CITY PLAN COMMISSION STAFF REPORT

November 1, 2022

Project Name
3rd and Grand

CD-CPC-2022-00164
Rezoning
Development Plan

**SHEET
 C201**

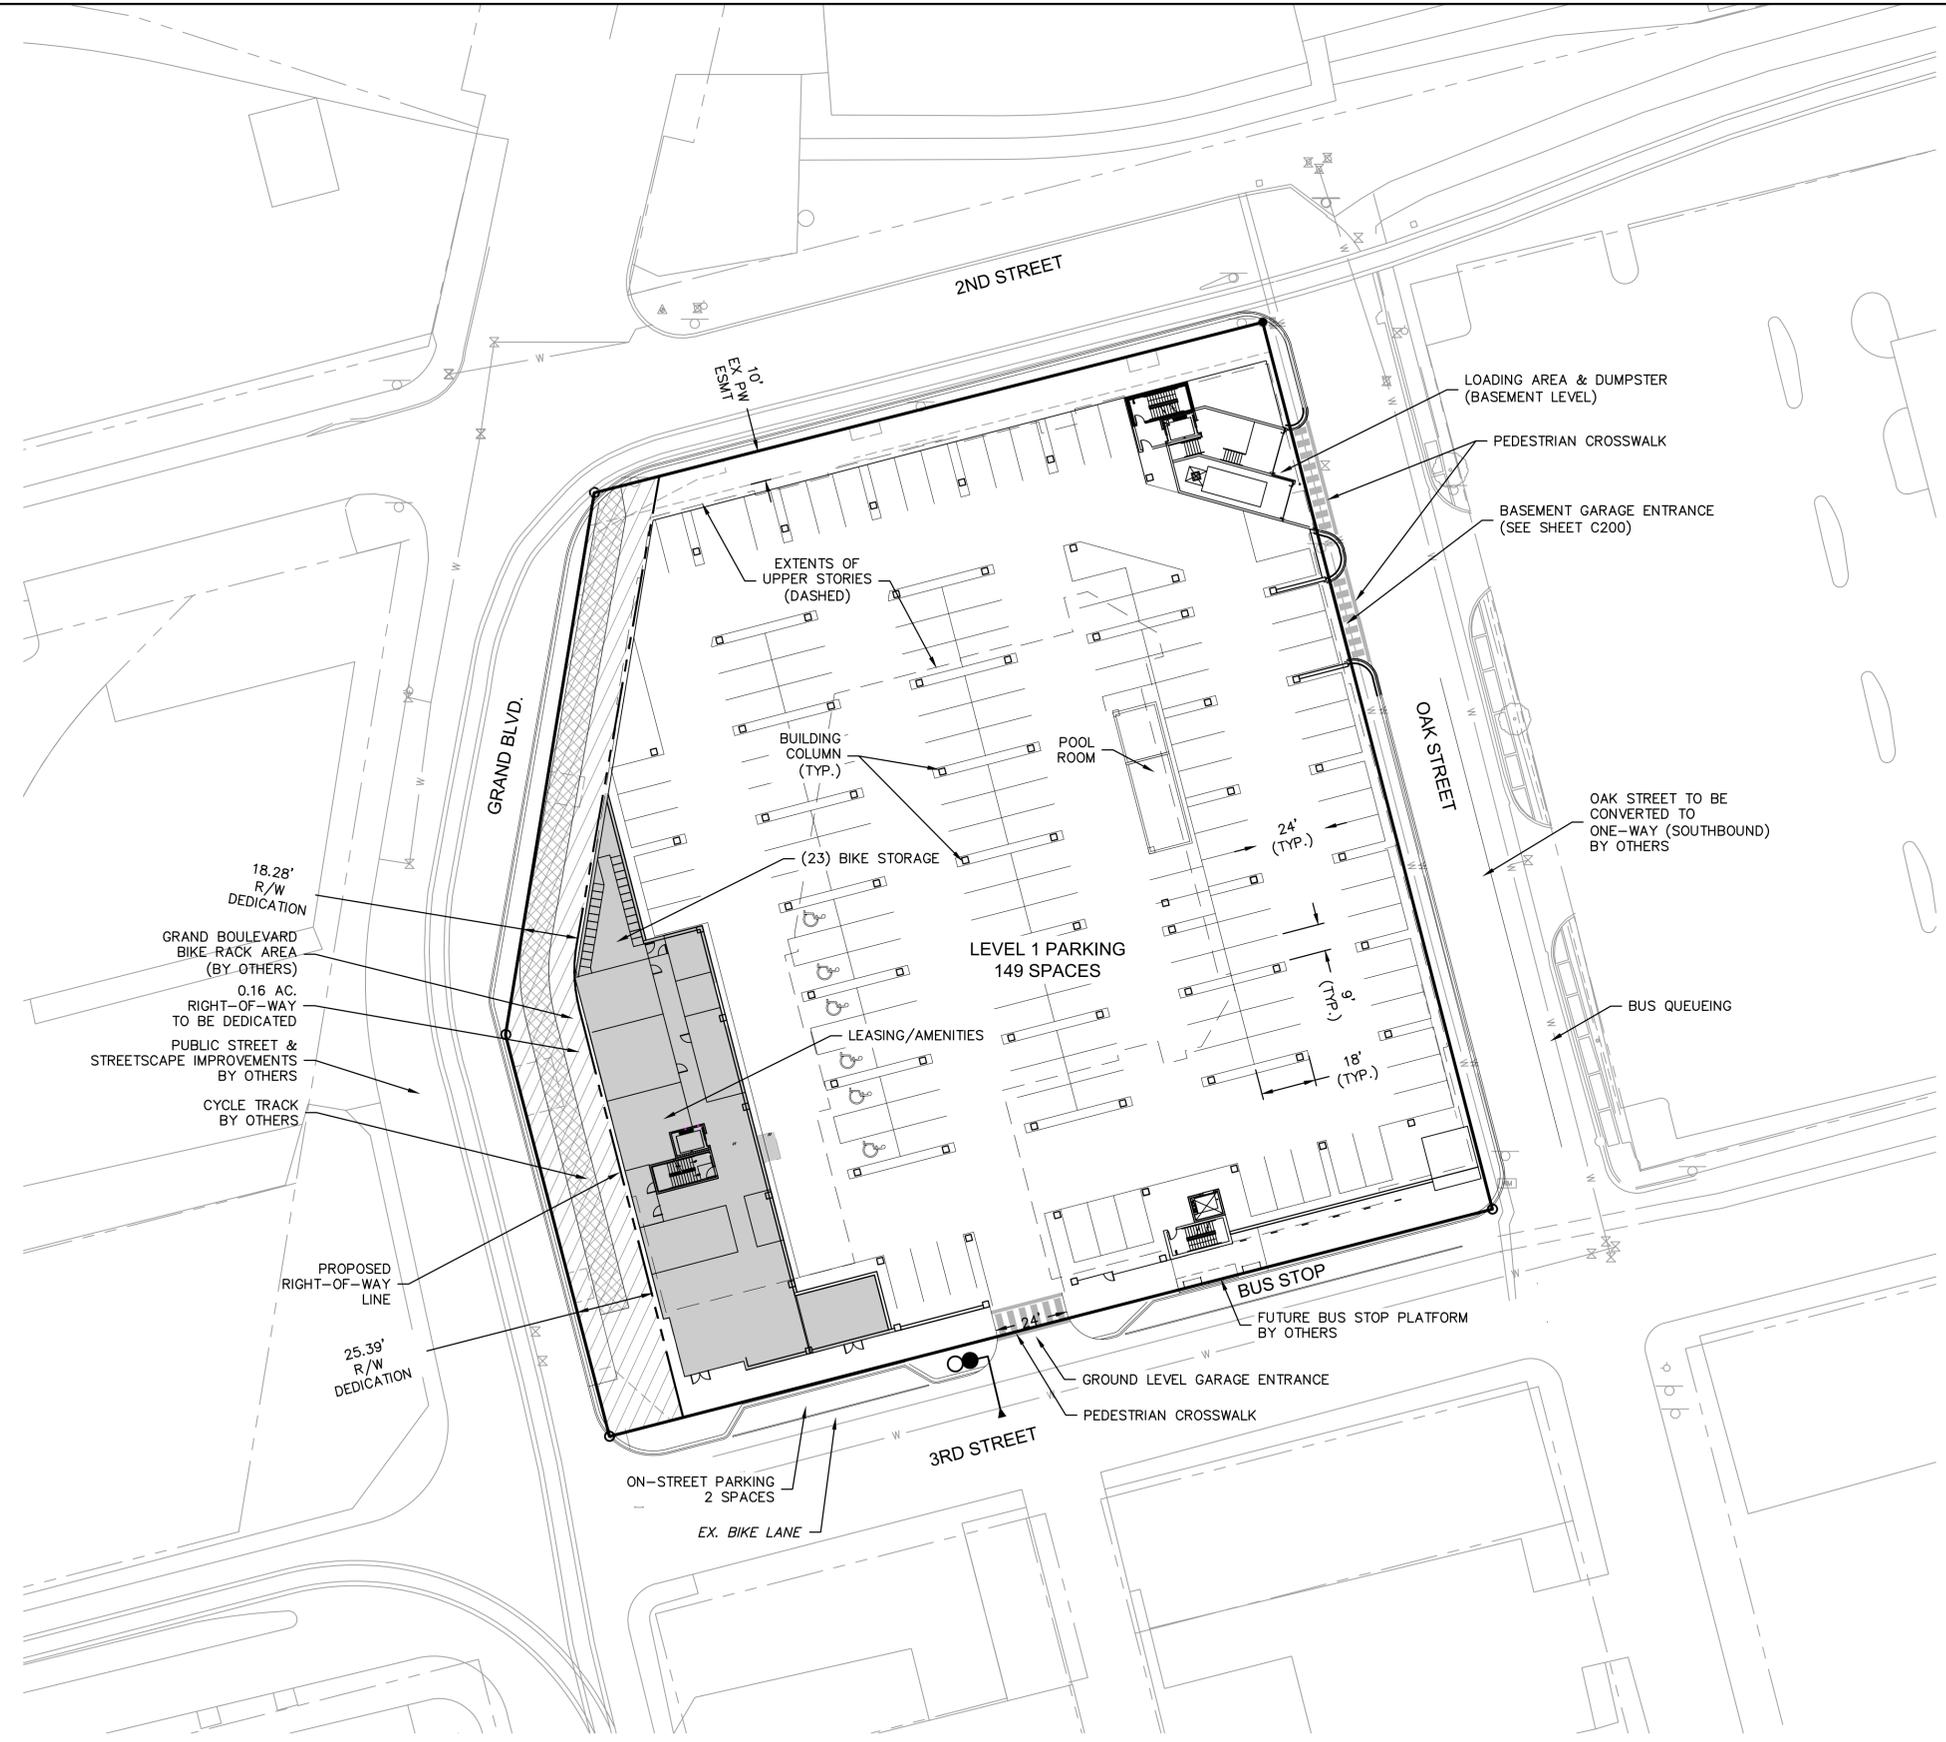
Section 88-323-02-C of the Zoning and Development Code states with regard to structured parking that “the ground level street frontage, with the exception of pedestrian ingress/egress, shall be improved with retail, office, residential, or other uses...”. The proposed plan does not meet this requirement. The number of parking spaces would need to be reduced in order to comply given the shape of the lot (it narrows in this portion) and the additional right-of-way requested by the Public Works Department. Therefore, the applicant is seeking a deviation from this requirement and permission to work with staff to provide murals or art in-lieu. If the Commission believes the number of parking spaces proposed is appropriate, staff supports this deviation because it would be infeasible to provide the parking number and right-of-way required of the agreements and meet this requirement due to the limited depth of the lot in this location.

The Landscaping and Screening standards require a parking garage's ground-level street frontage must be screened with ground floor residential units, improved with retail or office, or screened with a densely planted landscape perimeter. The deviation is required because the proposed structure is located almost immediately on the property line adjacent to a right-of-way that will be owned by the City. Therefore, the applicant cannot place the required landscaping as screening on the ground level parking garage. The applicant is also required to provide a required number of parking spaces and is therefore not able to provide ground floor residential or retail uses.

8. That the developer be granted a deviation to 88-425-07 Screening of Parking Garages. An alternative to this will be reach prior to the approval of the Final UR Plan. The developer shall place the language in section 88-425-07 on the landscaping plan.

9. The developer shall work with staff to identify building materials, fenestration, architectural details or lighting, art or a combination thereof, to improve the pedestrian experience along the ground level of the garage along all street frontages, giving greater emphasis to Grand Blvd, and depict such details on the final UR plan submittal

A200 - EAST & WEST BUILDING ELEVATIONS

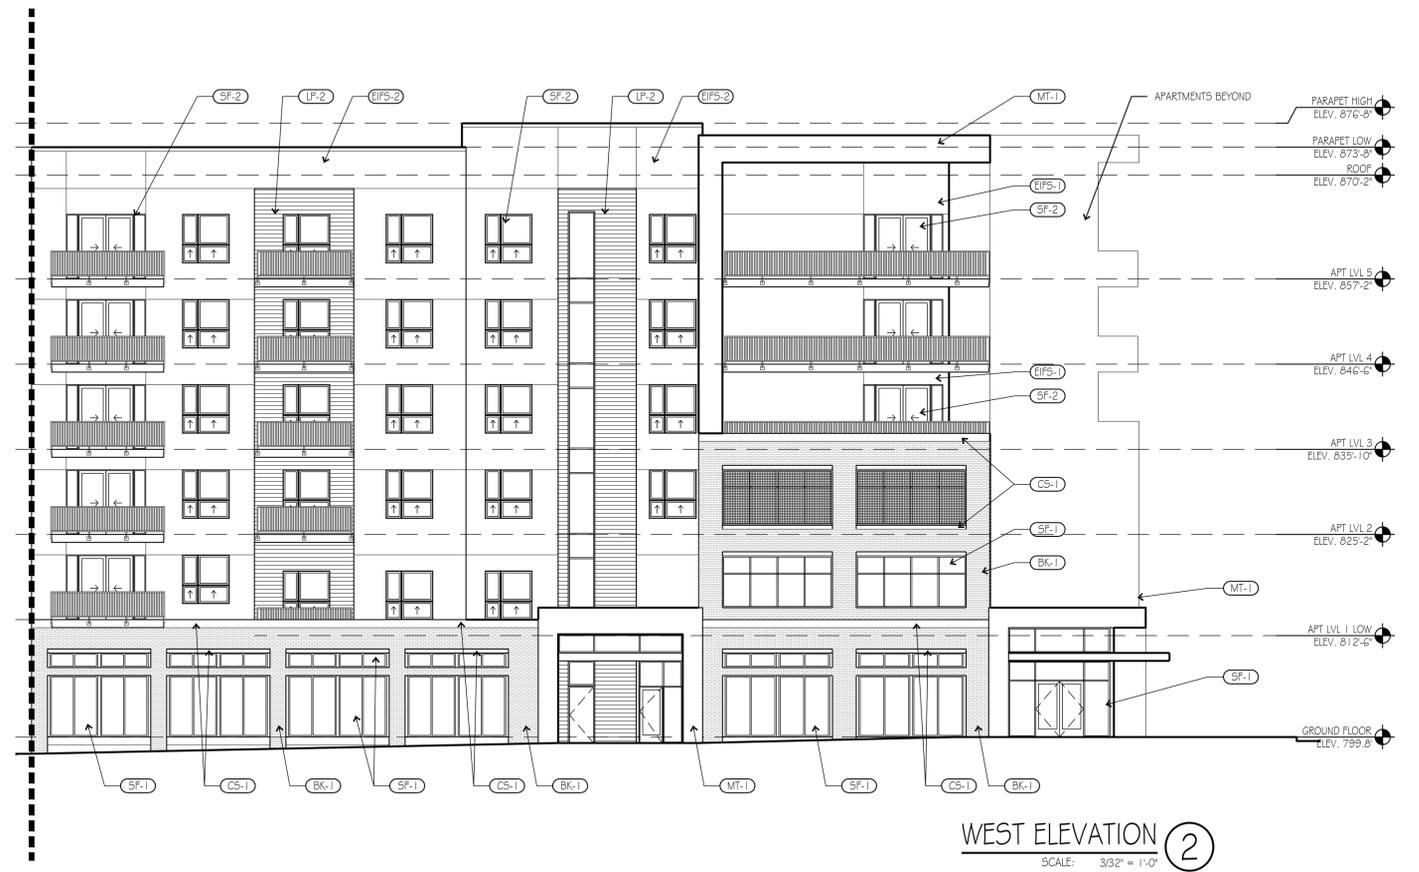
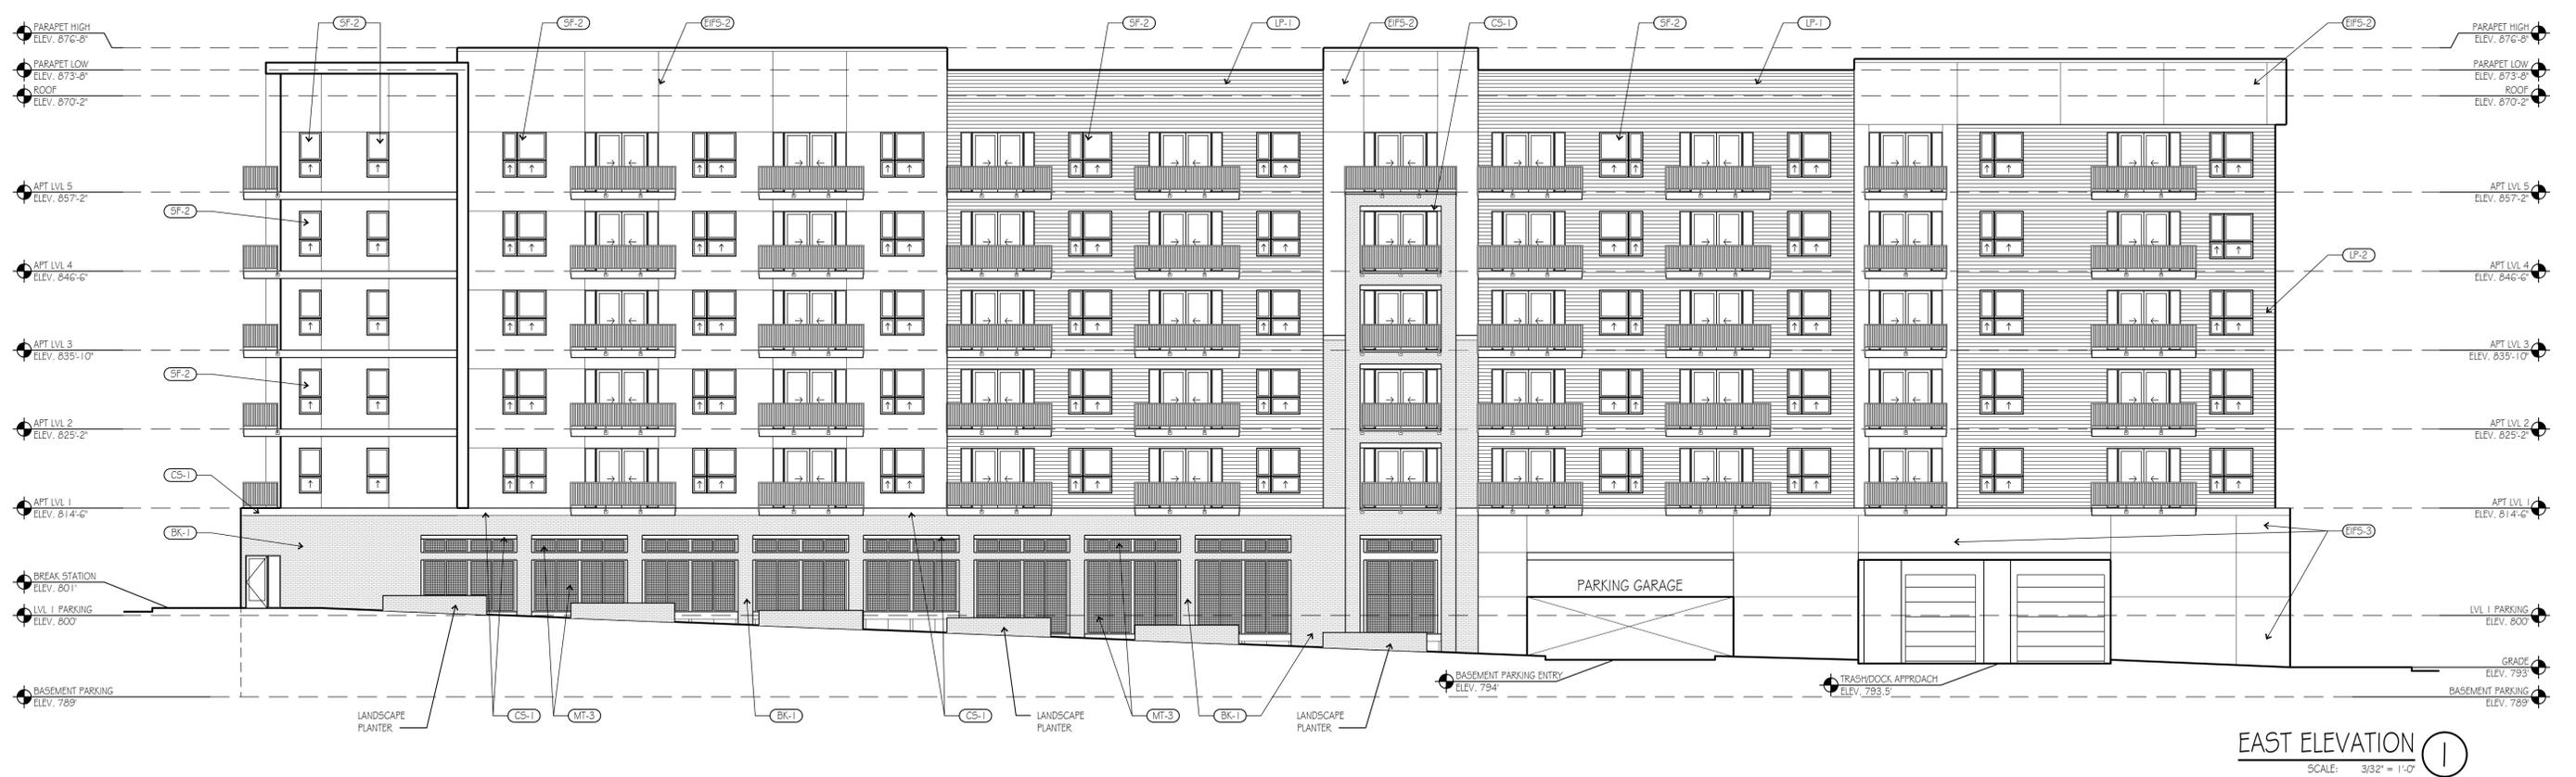
The construction materials for the proposed building are a mix of brick, cast stone, EIFS/stucco, metal, metal mesh, and lap siding. The applicant is proposing art as an additional way to accent the facades of the parking garage.

The developer is proposing alternative forms of landscaping and art walls that will help mitigate the blank walls of the parking garage.
